SPRINGFIELD SUBDIVISION

The purpose of this application is to resubdivide four existing parcels into 109 lots.

APPLICATION NUMBER 12 DATE March 3, 2005	_ N
APPLICANT Springfield Subdivision	_ ≬
REQUESTSubdivision	_ 1
	NTS

DETAIL SITE PLAN

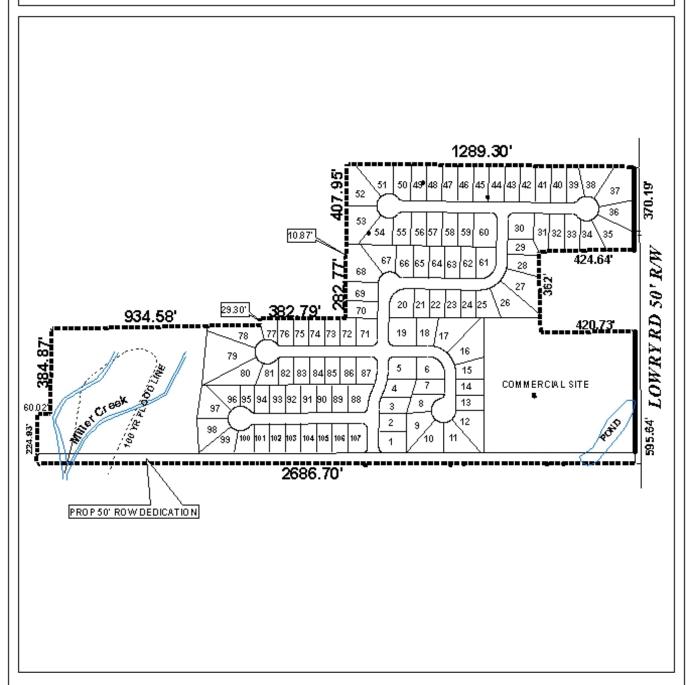
Because the site is located adjacent to two proposed major streets, access management is a concern. Assuming proposed improvements to Grelot Road and the Dawes Road connector occur, the residential portion of the proposed subdivision (lots 1 through 107) will have one access point to Grelot Road, and no connection to Dawes Road. The provision of one point of access for 107 lots creates an emergency access concern, and it is recommended that a second access-point be provided to the Dawes Road / Airport Boulevard connector, in the vicinity of Lot 36. However, no direct access to Grelot Road or the Dawes Road / Airport Boulevard connector should be permitted for Lots 1-107, as they will be served by the subdivision's internal roadway.

Lots 108 and 109 should be permitted direct access to the proposed extension of Grelot Road and the Dawes Road / Airport Boulevard connector. Access for Lot 108 should be limited to three

curb cuts to Grelot Road extension, and Lot 109 should be limited to three curb cuts to both Grelot Road and the Dawes Road / Airport Boulevard connector.

The 25-foot minimum building setback lines are not shown but would be required on the Final Plat, if approved. The minimum building setback lines should reflect requested right-of-way dedications.

- 3) the provision of a second roadway entry point for the subdivision, to be located in the vicinity of Lot 36, connecting to the proposed Dawes Road / Airport Boulevard connector;

- 1) placement of a note on the final plat stating that no street shall be constructed and Lots 1-109 shall not be recorded until the Grelot Road extension or the Dawes Road / Airport Boulevard connector are constructed and dedicated, where adjoining this subdivision;

- 2) dedication, via a deed, of rights-of-way sufficient to provide a minimum of 50 feet from centerline of Grelot Road and the Dawes Road / Airport Boulevard connector;

- 5) placement of a note on the Final Plat stating that Lot 108 is limited to a maximum of three curb cuts along Grelot Road extension, and Lot 109 is limited to a maximum of three curb cuts each to Grelot Road extension and the Dawes Road / Airport Boulevard connector, to be reviewed and approved by the Mobile County Engineering Department;

- 6) placement of a note on the Final Plat stating that Lots 1 through 107 be denied direct access to either Grelot Road extension or the Dawes Road / Airport Boulevard connector;

- 7) the depiction of the 25-foot minimum building setback line on the Final Plat (reflecting right-of-way dedication); and
